# PLANNED UNIT DEVELOPMENT & PLANNING APPROVAL STAFF REPORT

**NAME** American Tank and Vessel, Inc.

**LOCATION** 1000 Paper Mill Road

**CONTEMPLATED USE** Planning Approval to allow a petroleum storage and

## SITE PLAN

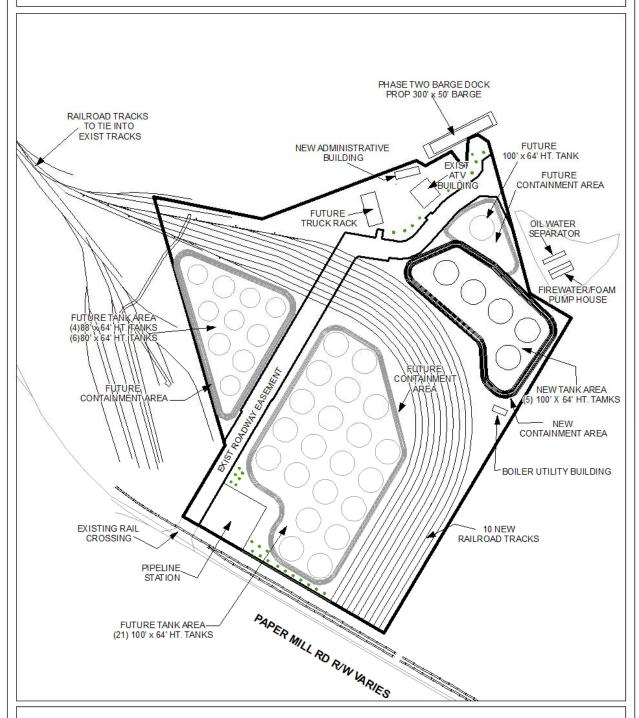
The applicant illustrates on the site plan the proposed construction of multiple structures, including 10 new railroad tracks, an administrative building, pipeline station, a boiler utility building, existing railroad crossing, 5 new tanks with a total storage capacity of 400,000 Barrels. However, the plan does not illustrate berm containment for the proposed 5 tanks. The site plan also depicts no parking.

The site plan also illustrates three future containment areas with a total of 32 tanks, each are 64 feet in height, totaling at 2,390,000 Barrels. The site plan illustrates a future truck rack, an oil water separator, firewater/foam pump house, barge dock, and an illustration of future

containment berms. The site plan illustrates that the oil water separator and the firewater/foam pump house are located on a separate parcel which is not part of the original PUD.

In the *detailed description* submitted with the application there were several discrepancies between the *detailed description* and the submitted site plan. In the *detailed description* it refers to a master dock building, existing docking facilities, elevated walkways, security fence, 31 future tanks with each tank having a capacity level of 80,000 barrels totaling 2,480,000 barrels and a "maybe" thermal incinerator or equivalent vapor combustion unit are not depicted on the site plan. The thermal incinerator and equivalent vapor combustion unit are substantial structures and are required to be depicted on the site plan.

On the site plan there are two unlabeled buildings that are not addressed in the *detailed description* submitted with the application. On the site plan the phases are not depicted nor are the proposed or future tanks numbered, they must be numbered for planning/permitting requirements.

According to the *detailed description* the 4 bay truck loading/unloading rack will be to load petroleum products from storage tanks onsite into road tanker cars. However, the future truck rack is unclear on the number of truck spaces provided and there is no vehicle circulation depicted on the site plan.

The 25-foot minimum building setback line is not depicted on the site plan along Paper Mill Road of the proposed building site; therefore, the site plan should be revised to illustrate the 25-foot minimum building setback line along Paper Mill Road. It should be noted no sidewalks are illustrated nor has a sidewalk waiver been requested. Therefore, the illustration of sidewalks or submission of a Sidewalk Waiver would be required.

The tree/landscape plan depicts inadequate tree and landscape frontage. A revised tree/landscape plan should be submitted or a submitted statement of why the applicant cannot meet the requirements of the Zoning Ordinance.

- 1) illustration 25 foot minimum building front setback line;
- 2) illustration of required parking for the 3,000 square foot administrative building;
- 3) illustration of site circulation and access for the northern portion of the site for the future truck rack and clarification of future truck rack;

- 4) illustration of proposed berm containment;
- 5) illustration and location of 250 square foot dock master building;
- 6) illustration and note of the proposed fence height and material;

- 7) illustration or note of total site coverage;
- 8) illustration of tank numbering system for planning/permitting;
- 9) illustration of the phases of construction/development;

- 10) illustration of walkways over tracks;
- 11) placement of note addressing the two unlabeled buildings;
- 12) illustration and/or note of existing docking facility location;

- 13) placement of note of type of tank;
- 14) placement of note of specific products to be stored in proposed and future tanks;
- 15) submission of revised tree/landscape plan in compliance with the Zoning Ordinance requirements or a note of why the applicant cannot meet the requirements;

- 16) removal of the illustration of the existing ATV building on the site plan;
- 17) the location and clarification of a thermal incinerator or equivalent vapor combustion unit on site;

- 18) illustration of sidewalks or the submission of a Sidewalk Waiver application;
- 19) compliance with Engineering comments: (1. Add a note to the PUD drawing stating that any work performed in the existing public ROW (right-of-way) such as grading, drainage, driveways, sidewalks, utility connections, irrigation, or landscaping will require a ROW permit from the City of Mobile Engineering Department (208-6070) and must comply with the City of Mobile Right-of-Way Construction and Administration Ordinance (Mobile City Code, Chapter 57, Article VIII). 2. Add a note to the PUD drawing stating that any and all proposed development will need to be in conformance with the Storm Water Management and Flood Control Ordinance (Mobile City Code, Chapter 17, Ordinance #65-007 & #65-045); the City of Mobile, Alabama Flood Plain Management Plan (1984); and, the Rules For Erosion and Sedimentation Control and Storm Water Runoff Control. 3. Add a note to the PUD drawing stating that any work performed within this development must comply with all Engineering Department Policy Letters. 4. Sidewalk along the frontage of public ROW is required, unless a waiver is approved.):
